Reliability Analysis Update

Transmission Expansion Advisory Committee

October 6, 2026

Dominion Transmission Zone: Baseline 500kV Line #588 Rebuild (End of Life Criteria)

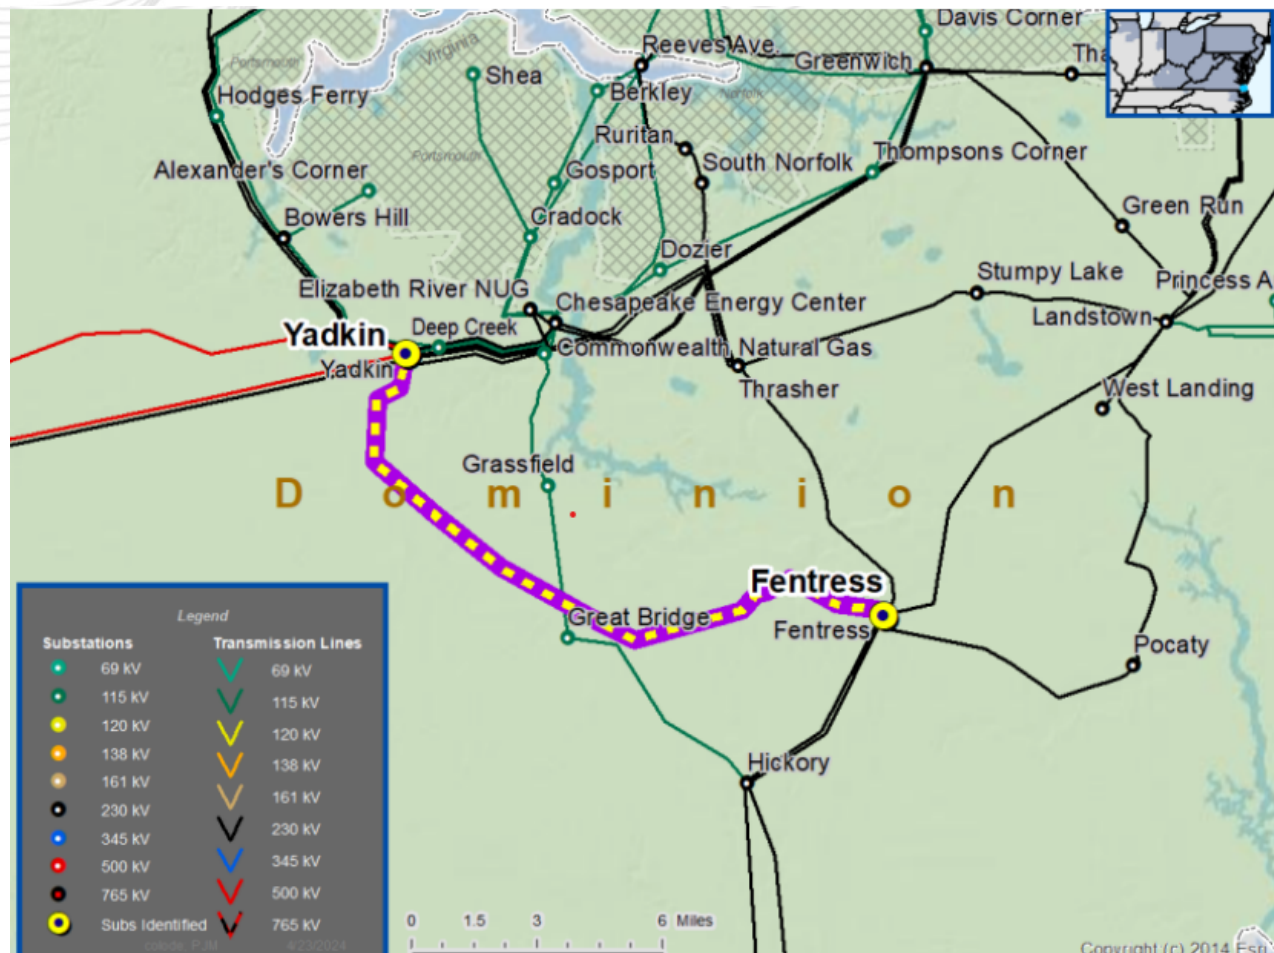
Cost Change for b3850.1 – b3850.3 (2023-W2-367) 500kV Line #588 Yadkin – Fentress Rebuild:

Transmission Estimated Cost: ~~\$79.7M~~ \$113.8M

- Construction bids for the transmission line work were received above the original estimate.
- Permitting delays resulted in schedule impacts, leading to change orders for both standby time and schedule acceleration.
- Material delivery delays affected project execution and required additional change orders to recover schedule and maintain project milestones.

Dominion Transmission Zone: Baseline 502 Jct-Woodside-Aspen 500 kV & Doubs Corridor Projects (DOM Portion)

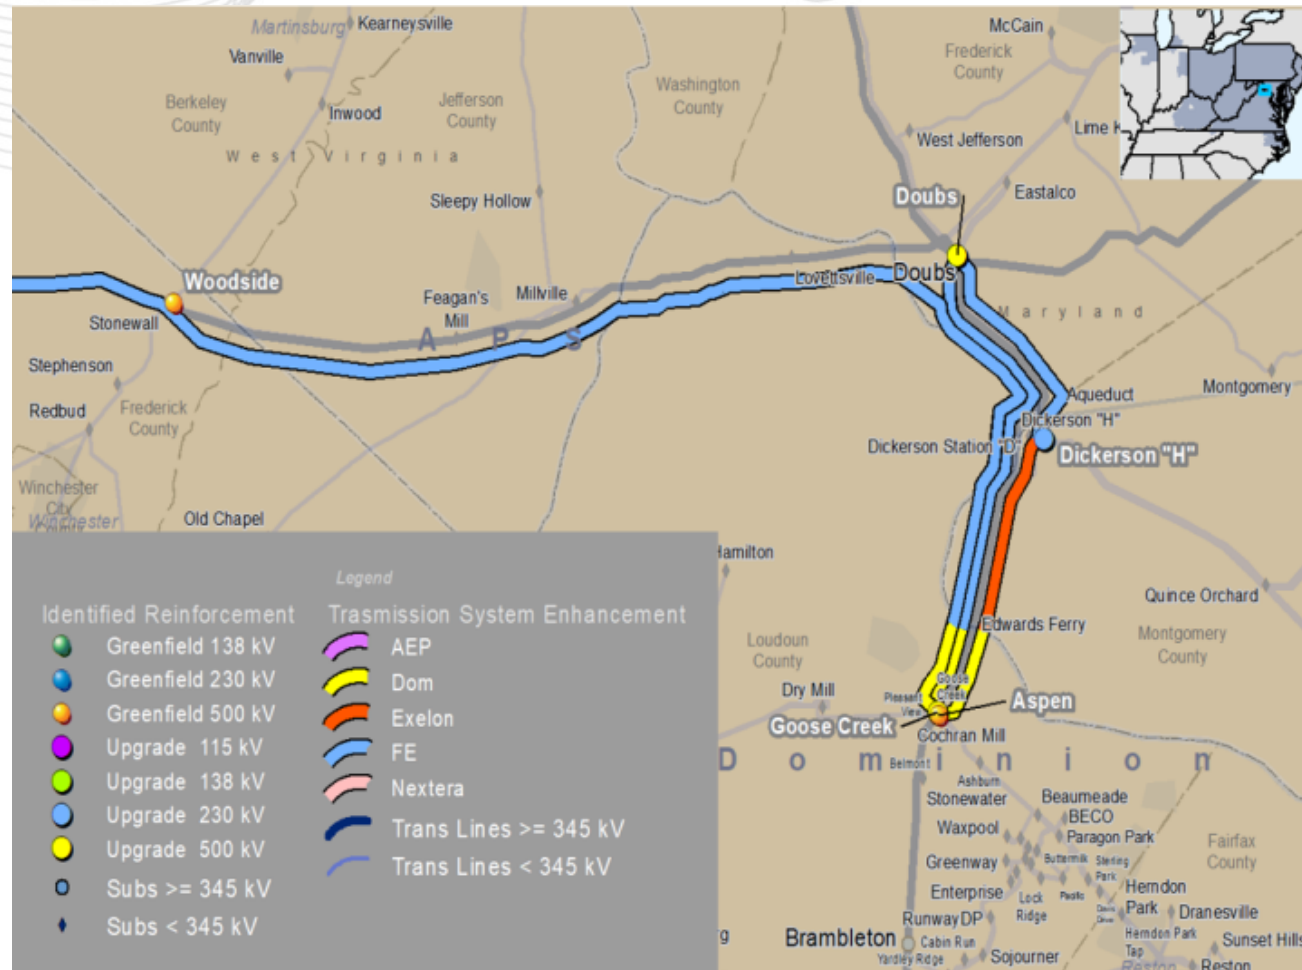
Cost Change for b3800.118, b3800.120 & b3800.375 (2022-W3-853) :

Transmission Estimated Cost: ~~\$51.19M~~ **\$73.94M**

- Project costs update are driven by upgraded conductor design, catwalk installation, updated geotechnical conditions, additional splice boxes, increased crossing requirements, taller structures for EMF and clearance compliance, and the inclusion of forestry and access work not accounted for in the previous project.

Dominion Transmission Zone: Thornburg 500/230kV Substation (Line #568 Ladysmith – Possum Point Cut-In)

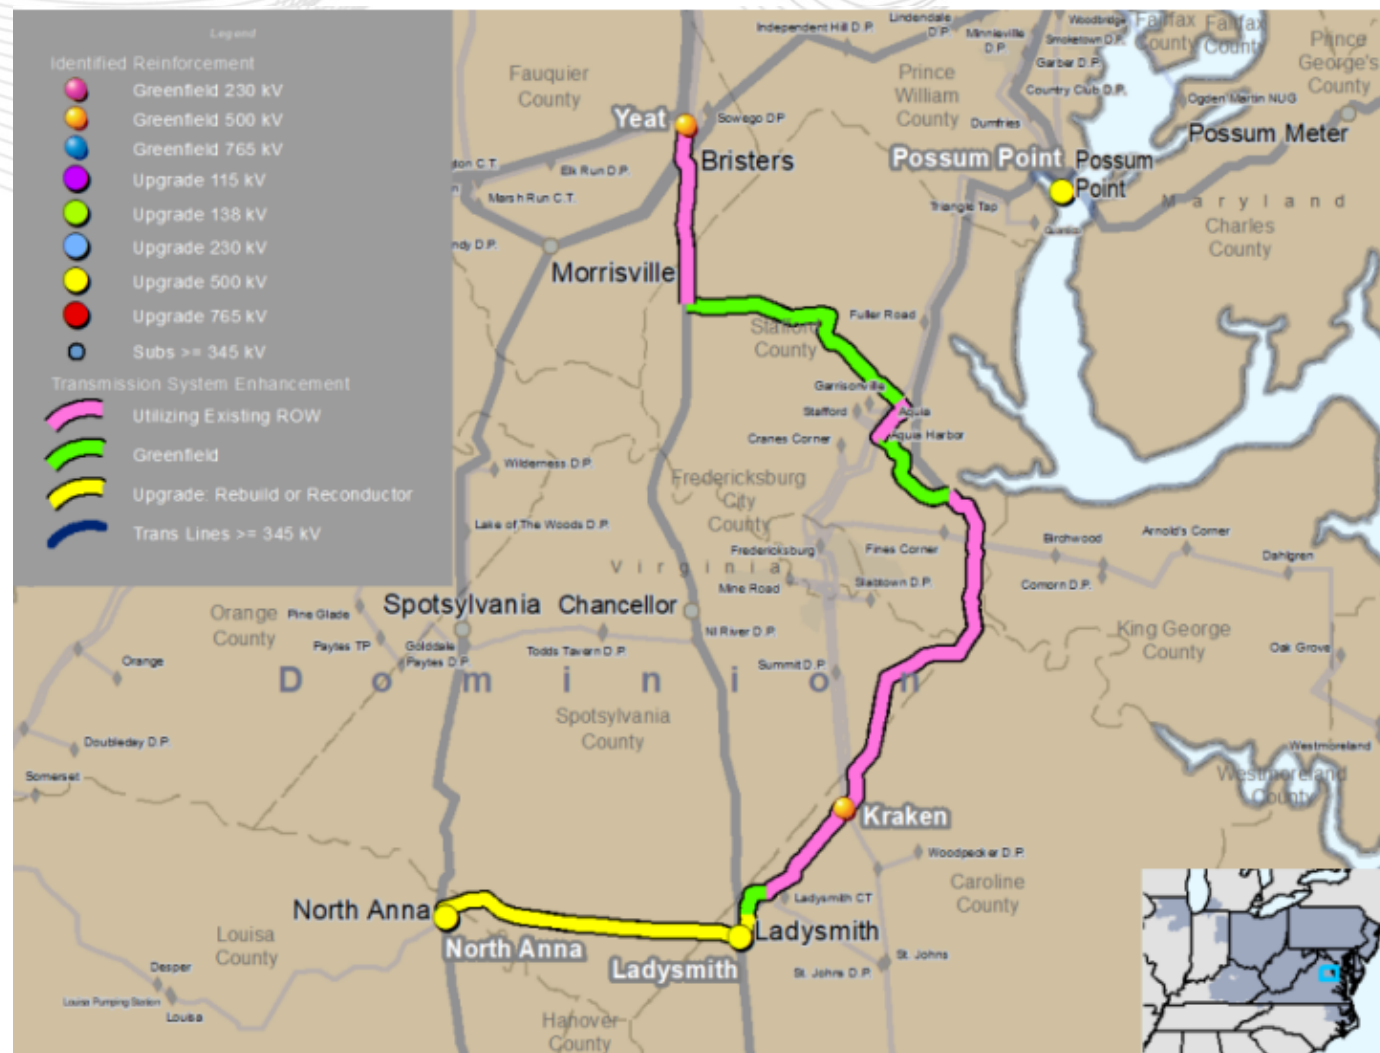
Change in Description & Cost for Original Baseline IDs:

- Cut into line 568 Ladysmith to Possum Point and run to the line of demarcation at Thornburg substation (Ladysmith - Thornburg portion). **Estimated Cost: \$1.1M (b4000.351)**
- Cut into line 568 Ladysmith to Possum Point and run to the line of demarcation at Thornburg substation (Possum Point - Thornburg portion). **Estimated Cost: \$1.1M (b4000.352)**

- Terminate line 568 Ladysmith to Possum Point from the line of demarcation into Thornburg substation (Ladysmith - Thornburg portion). **Estimated Cost: \$2.5M (b4000.364)**
- Terminate line 568 Ladysmith to Possum Point from the line of demarcation into Thornburg substation (Possum Point - Thornburg portion). **Estimated Cost: \$2.5M (b4000.365)**
- The designated entity for both new baseline IDs is **Valley Link Transmission**.

- Further discussion between Valley Link Transmission & Dominion determined that the work for the cut-in of 500kV line #568 Ladysmith – Possum Point into Thornburg substation should be split as highlighted above.

Dominion Transmission Zone: Thornburg 500/230kV Substation (Bypass Elmont & Possum Point 500kV)

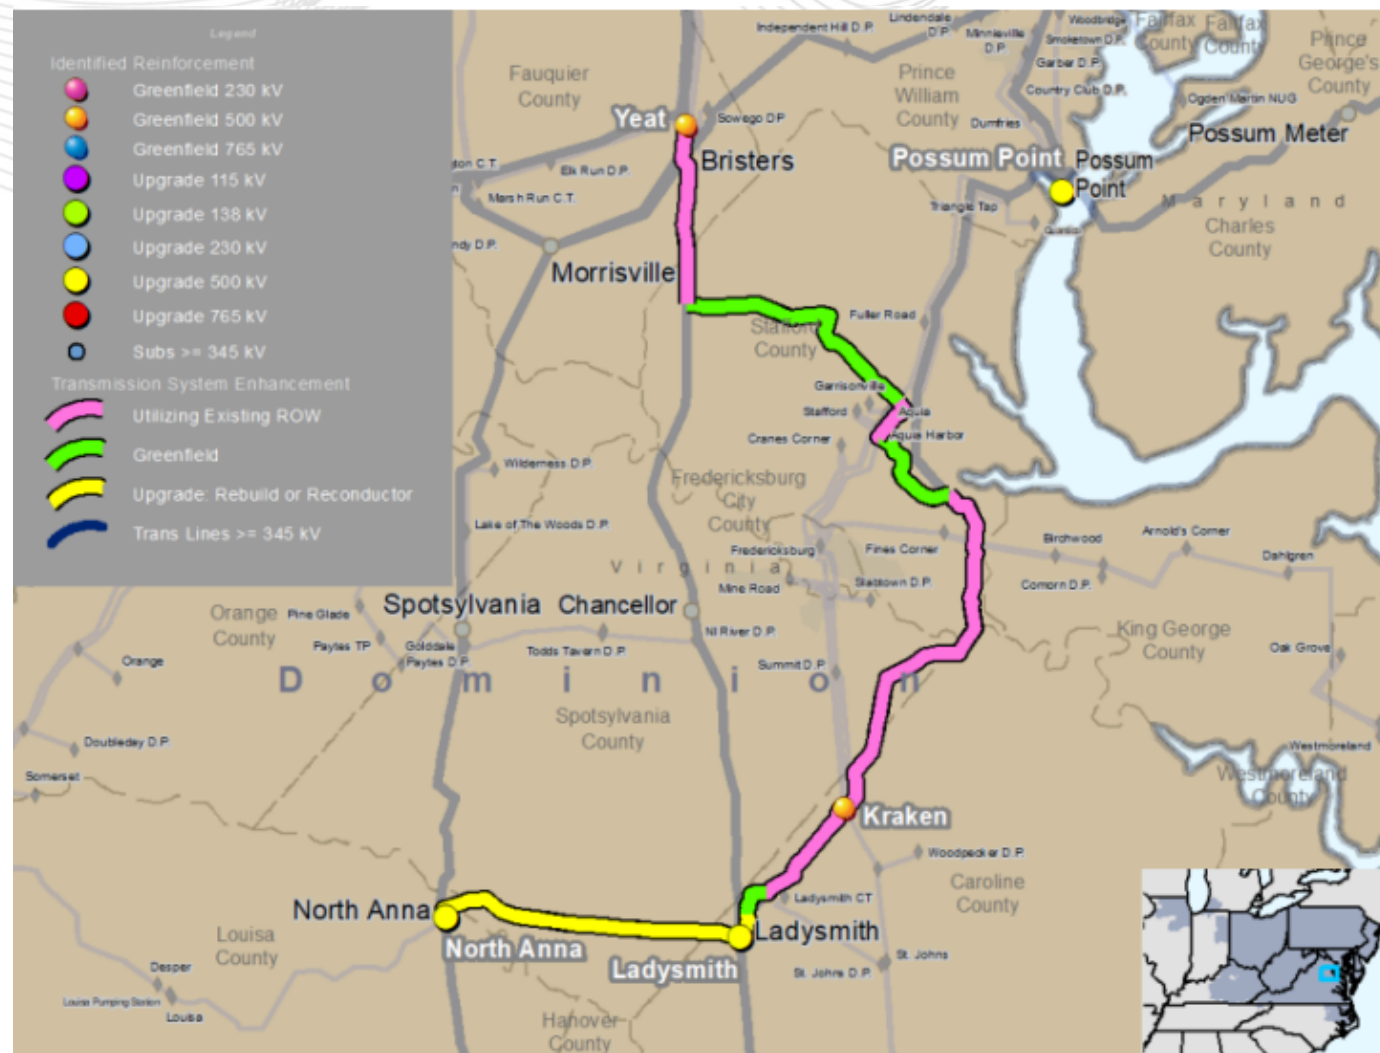
Change in Designated Entity:

- Further discussion between Valley Link Transmission & Dominion determined that the designated entity for this baseline ID should be Valley Link Transmission over Dominion.

Dominion Transmission Zone: Nokesville – ~~Hornbaker~~ Bristow New 230kV Line

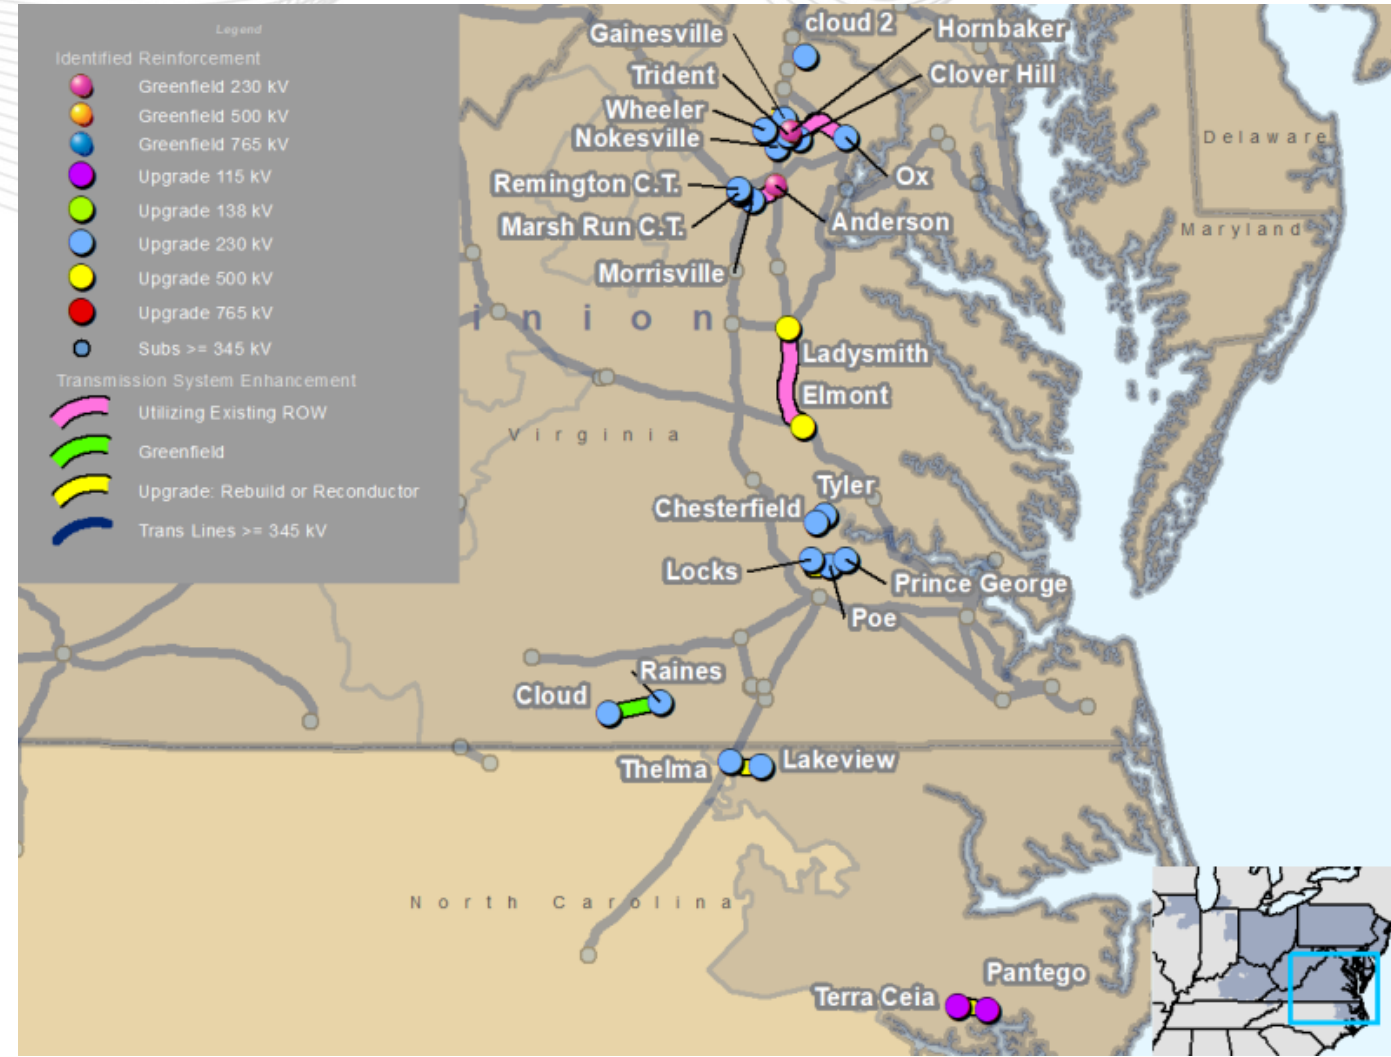
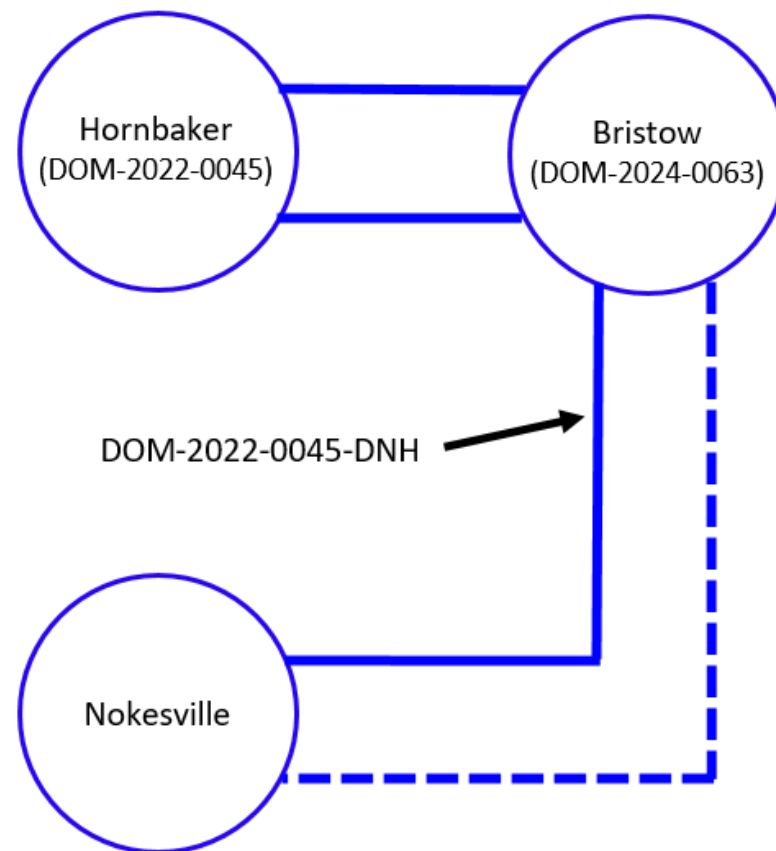
Scope Change for b4000.322 – b4000.324 (230kV Line Nokesville – Hornbaker 230kV line):

- Bristow will be located directly adjacent to Hornbaker. At the 12/03/2024 TEAC meeting, the scope of DOM-2022-0045-DNH (Nokesville-Hornbaker 230 kV Ckt #1) was reconfigured to terminate from Nokesville into Bristow rather than Hornbaker. This change applies the same update to the second 230 kV circuit.

- Build a new 230kV Line from Nokesville – Bristow using the vacant arms of the double circuit monopole structures installed as part of previous supplemental project s3035.2. **Estimated Cost: \$15.28M (b4000.322)**
- Terminal equipment upgrades at Nokesville and Bristow 230kV substations. **Estimated Cost: \$2.86M (\$1.43M: b4000.323 & \$1.43M: b4000.324)**

B4036.15 Scope Change

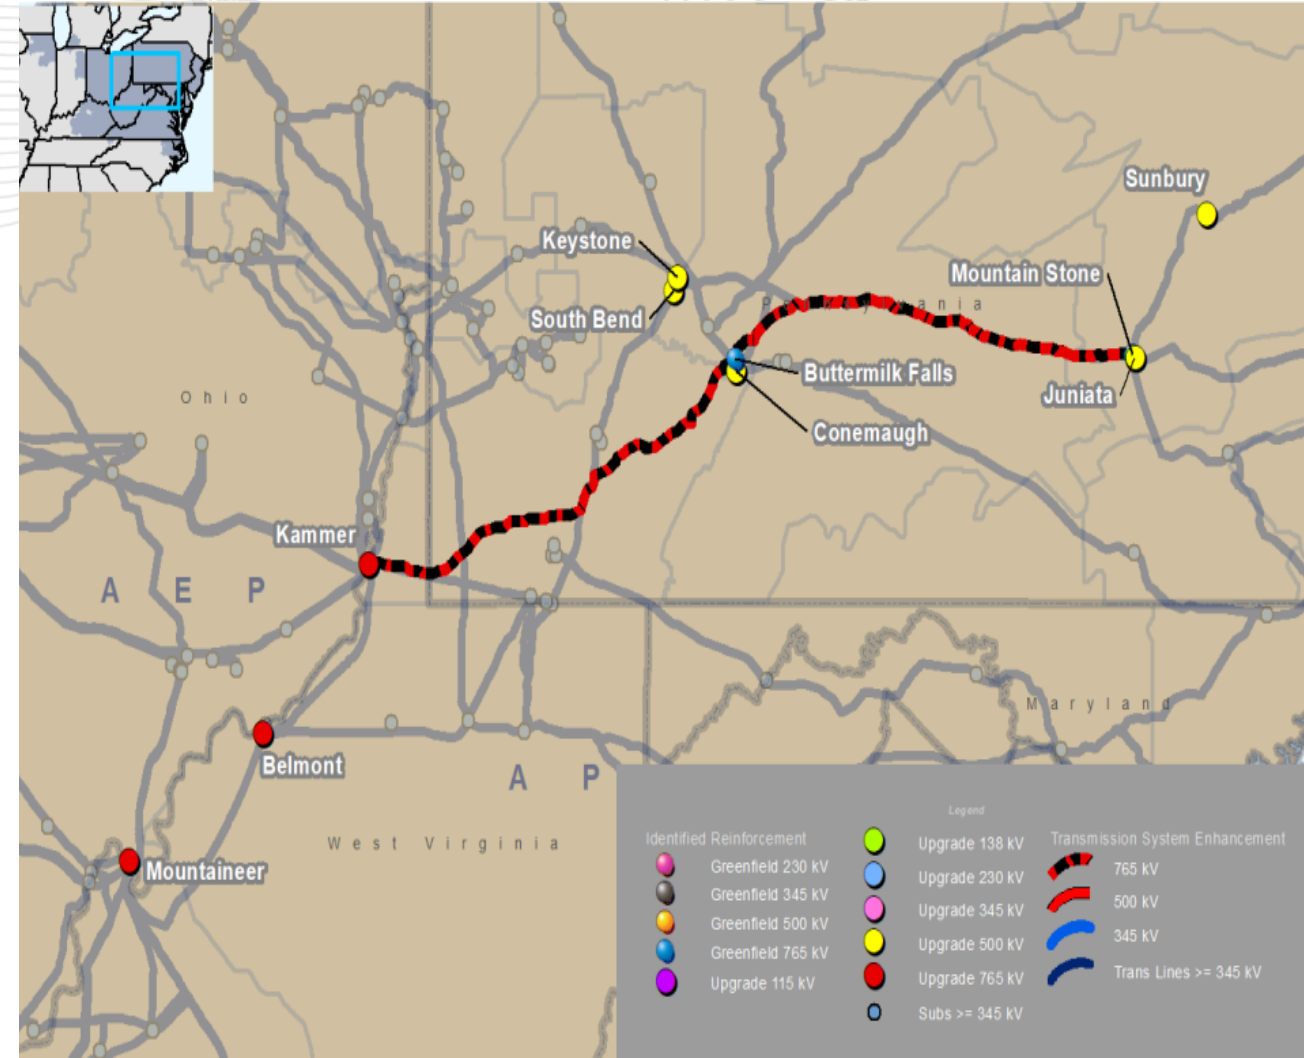
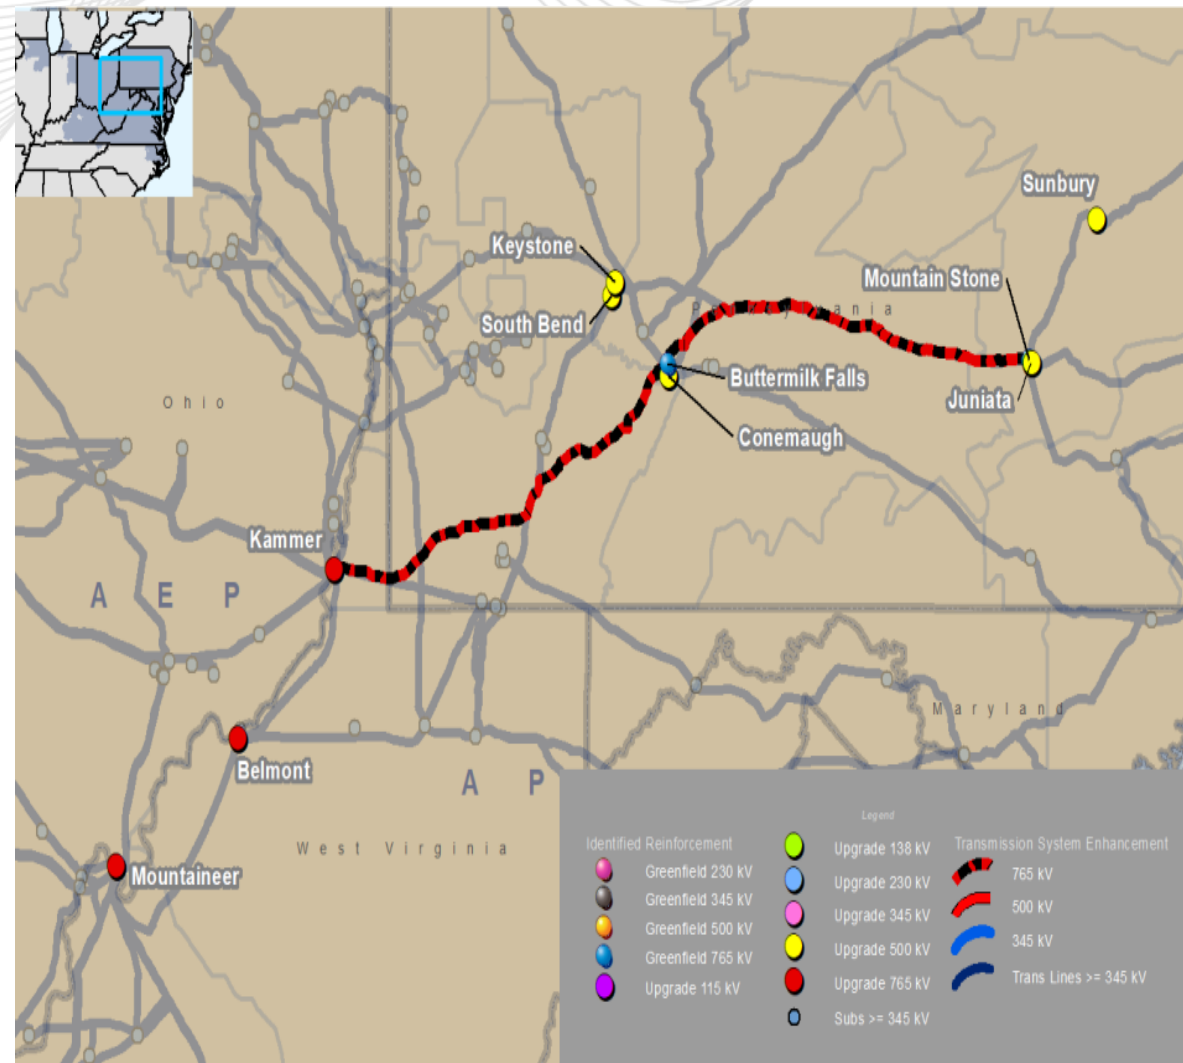
Old Scope: Install two new 500 kV CB at North and South bus to terminate the 765-500 kV transformers leads

PPL has completed its review of the NextEra proposed scope. The evaluation identified broader scope of work than originally anticipated. The additional scope involves constructing a new station adjacent to the existing facility.

- Bringing the 765/500 kV transformer lead lines into the existing Juniata 500 kV buses would cause thermal requirements that exceed the capability of the existing Juniata 500 kV buses.
- Given outage constraints and the limited footprint of the existing Juniata Substation, it is not feasible to upgrade the existing facility to meet the required rating
- The Juniata 500 kV Substation is already the designated termination point for multiple new 500 kV transmission lines, further limiting expansion and upgrade options

New Scope: Build new Juniata 500 kV station adjacent to the existing Juniata station and re-terminate a portion of the 500 kV transmission lines at the new substation.

New Estimated Total Cost: \$131.53M
